Docket Item #s 3, 4 & 5
BAR CASE #2010-
0171/172/173

BAR Meeting
July 21, 2010

ISSUE: Partial Demolition, Alterations and Signs

LOCATION: 106 South Union Street

Portions of the brick wall proposed for demolition

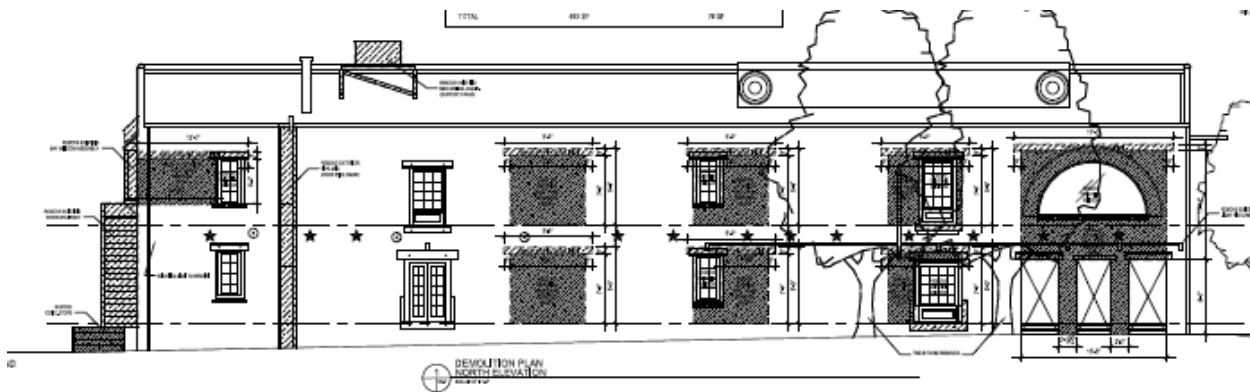
In this case, although the building itself is one of a small remaining sample of historic warehouse buildings on the waterfront, the severely simple exterior masonry walls are not of uncommon design, texture or material and could be reproduced easily. The amount of masonry to be removed is relatively small and will even be slightly less based on the revised entrance design shown in the

supplemental drawings. In addition, any masonry or lintels removed to enlarge the window or door openings will be salvaged for reuse on the interior. Therefore, Staff believes that none of the criteria are met for the small amount of masonry proposed for demolition and the Permit to Demolish/Encapsulate should be granted.

View from the Strand, as revised in the supplemental materials

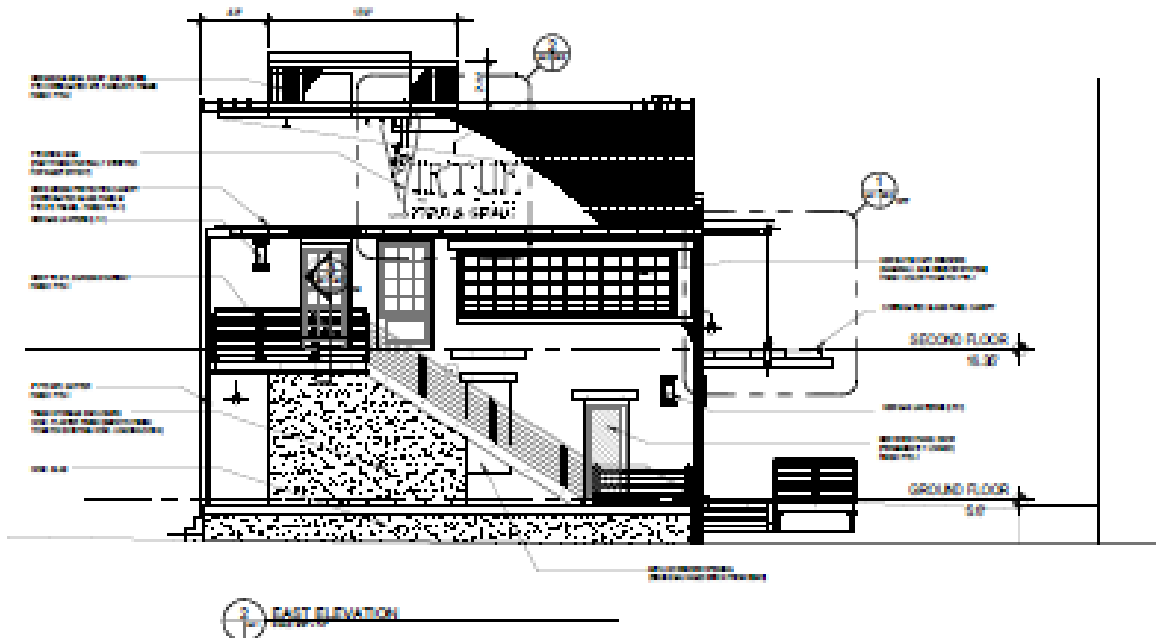
The proposed windows at the northeast corner of the second floor connect the existing bay window on the east with a single window on the north wall. These windows will be aluminum, simulated divided light, accordion folding sash by Nanawall (sht. A8.2). While the corner window was not a widely used form on early Alexandria warehouse buildings, staff has no objection to this window in this location. Steel sash corner windows were used on a number of Alexandria buildings during this early 20th century period and this proposal expresses the contemporary repurposing of these buildings as the character of Alexandria's waterfront has evolved and views of the river have improved. The architect studied numerous window alternatives for this location and none had the visual balance or honest architectural expression of the current proposal. All windows and doors and new steel channel lintels will be painted black to reflect the typical historic metal sash color, according to the proposed color scheme.

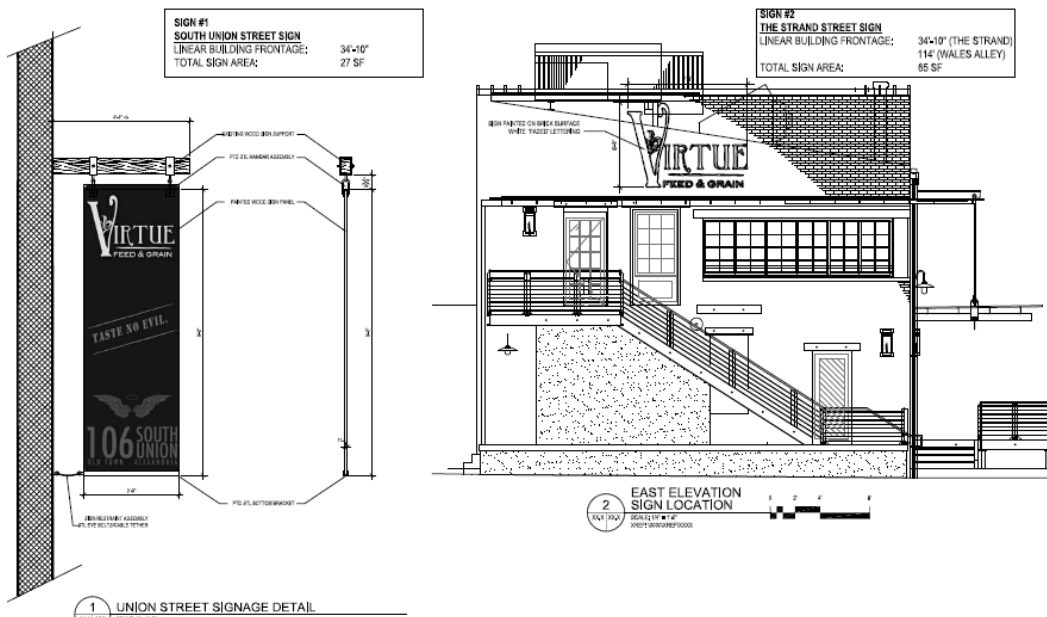
The new restaurant will require larger rooftop HVAC equipment than the previous retail use did. The applicant, therefore, proposes a corrugated metal screen on three sides of the equipment, which has been grouped at the east end of the roof. (sht. A2.3 & A5.4) The screen will be painted off-white to match the existing membrane roofing.

If during construction, the applicant finds the existing roof must be replaced, staff recommends a historically appropriate standing seam metal with the mechanical screen to match the material, design and color and has recommended this as a condition of approval. Staff suggests that oxide red would be the most historically appropriate metal roof color for this warehouse.

1. That the entrance be as shown in the supplemental drawings;
2. That if the existing roofing must be replaced that standing seam metal be used and that the rooftop mechanical screen be the same material, design and color;
